Subject: Fwd: NYM/2021/0353/FL, Nookside, Whitby Road, Robin Hoods Bay, YO22 4PB

Nookside, Whitby Road, Robin Hoods Bay, YO22 4PB

Your ref NYM/2021/0353/FL

Existing and proposed drive frontage.

Drive frontage layout
Existing

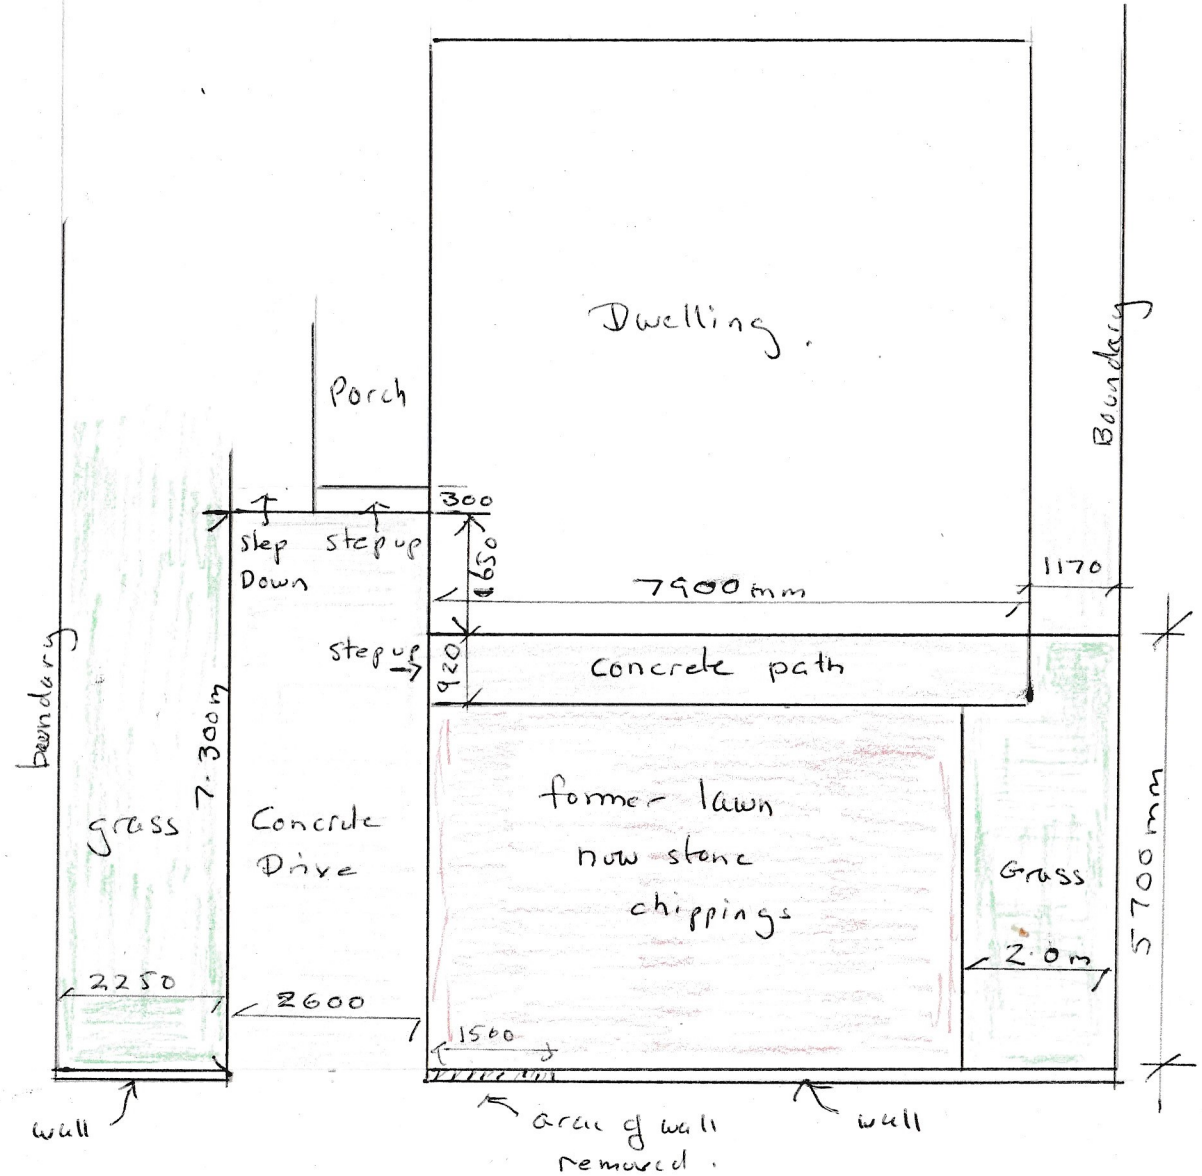
The property currently has a concrete drive entrance from the main road which is approximately 2.6m wide and is located up to the entrance porch steps giving a total length of 7.35m. Up until less than three years ago this was the only access/hard standing for vehicles at the property as the rest of the frontage was garden or lawn. This is still visible on google street scene.

A few years ago the previous owner covered the lawn with membrane and laid stone covering to provide more parking for the tenant who ran a local business at another location. I presume this is when the small section of wall was removed at the front to give access to his large van.

It is currently difficult to drive in and manoeuvre around the frontage due to the drop off the side to the lower lawn, slope of the site and various steps.

Nookside
Whitby Road - RHB
Scale 1:100
Drive frontage
Proposed
ref 20-05-10

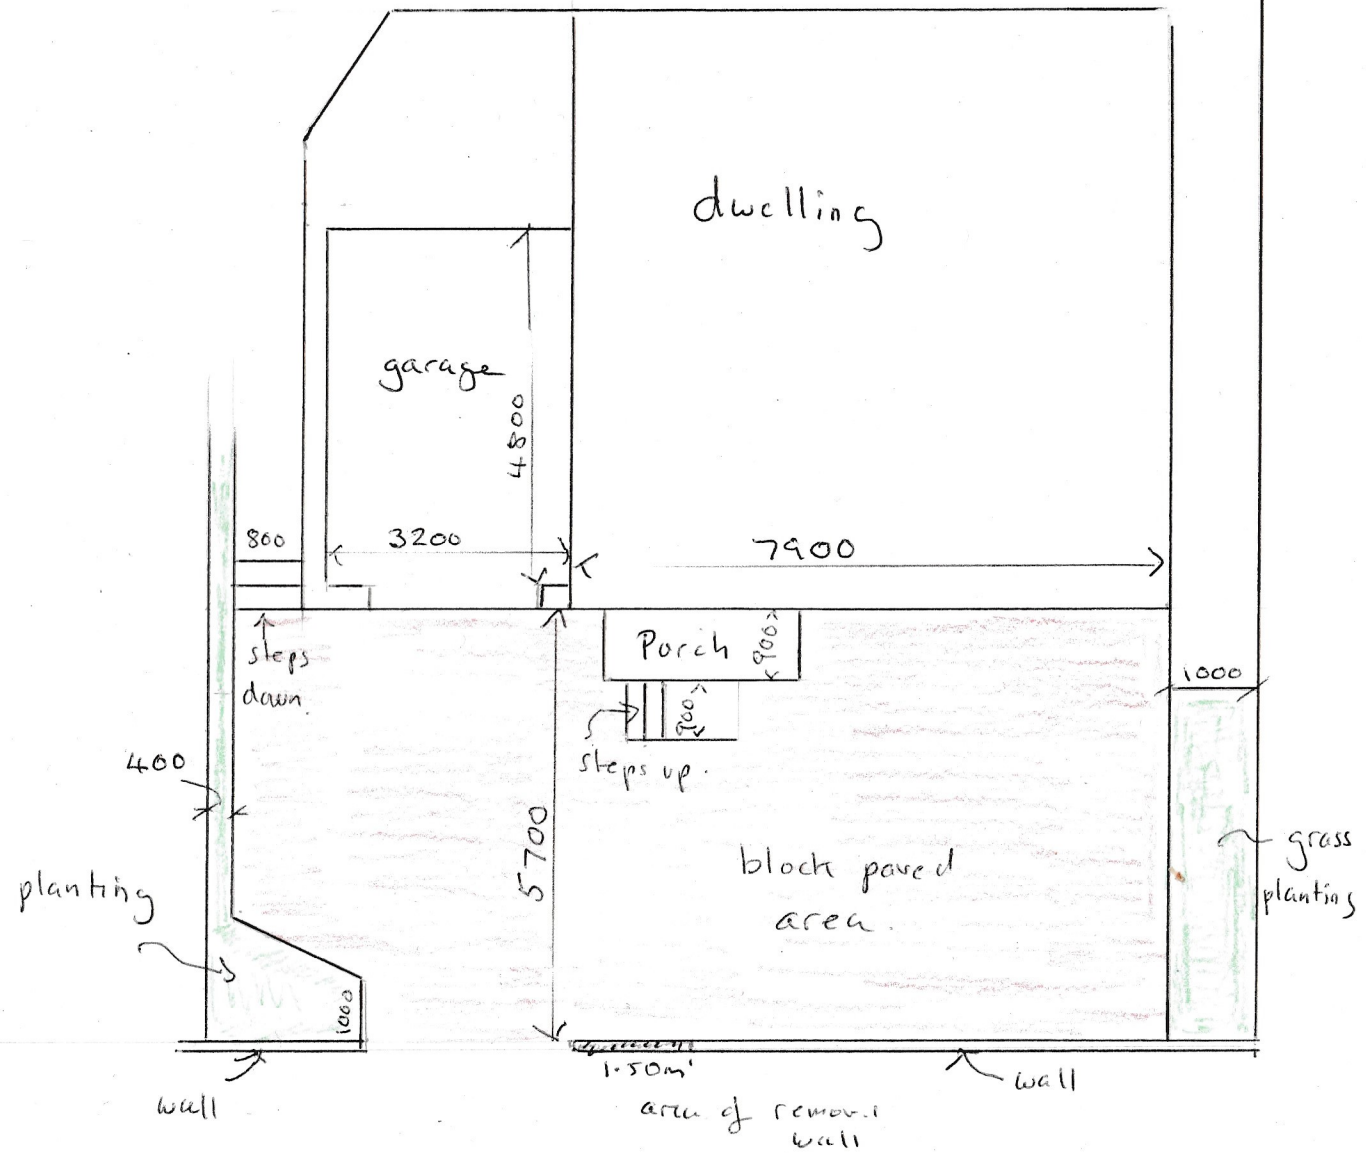
In time it is proposed to block pave the frontage and reduce the lawn/planting areas to allow greater manoeuvrability around the front. You should be able to drive in forward and pull in to the side of the garage and reverse up the slope to the larger paved area which would mean that most of the time you should be able to access the main road going forward which is not currently possible.

The garage internal Dimensions give a clear internal width of 4.8m x 3.2m with a door with of 2.1m It is proposed to use an electric roller type door so that vehicles can pull up right in front of the door. I understand this is not in line with parking standards. However, this is to garage a classic vehicle which is of small size to today's modern cars. There is also limited ground available to extend and still allow access to the rear of the property.

The door width could be increased if it is felt that helps the issue positively.

I understand the concern of loose materials currently washing onto the pavement/highway and would look to resolve this at some point regardless of the current planning application. Your comment has been noted.
